## **NOTICE OF DECISION**

DATE: July 31, 2023  
PROJECT NAME: Pecos Pit  
PROJECT LOCATION: 1010 and 1110 Yelm Ave E, Yelm, WA 98597  
PARCEL NUMBER(S): 22730110206 and 22730110207  
CASE NUMBER: MU 2023.0042

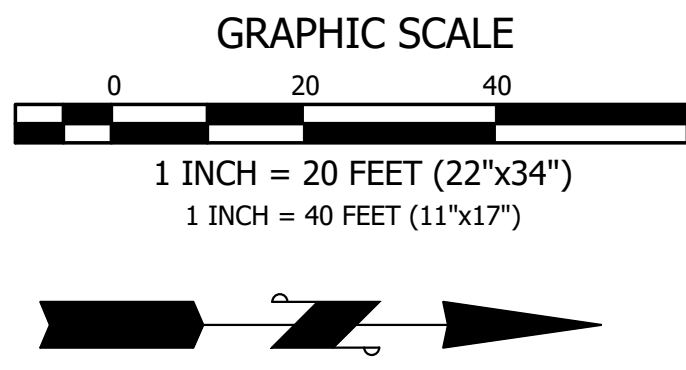
The Site Plan Review Committee's decision in this matter may be appealed pursuant to Chapter 18.10 YMC, to the City of Yelm Hearing Examiner no later than 21 days from the date of this decision. An appeal must be in writing, contain specific factual objections, and include the appeal fee of \$1,250.00.

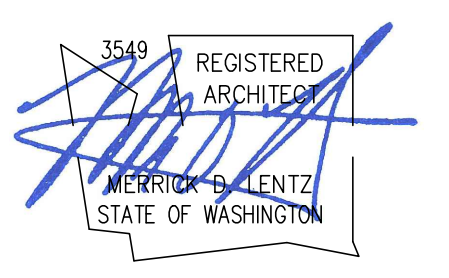
- Comments:**
- 1) The location of project site on vicinity map is incorrect.
  - 2) Frontage Improvement is required on NE Plaza Dr.
  - 3) On Existing site plan, please remove the sidewalk notes as it is a driveway approach.
  - 4) (Suggestion) Please change the color or draw a frame around the "PEDESTRIAN PATH TO THE PUBLIC WAY"
  - 5) Please remove the SHEET INDEX if there is only one sheet
  - 6) Please edit the fonts because some of the words are impossible to read.
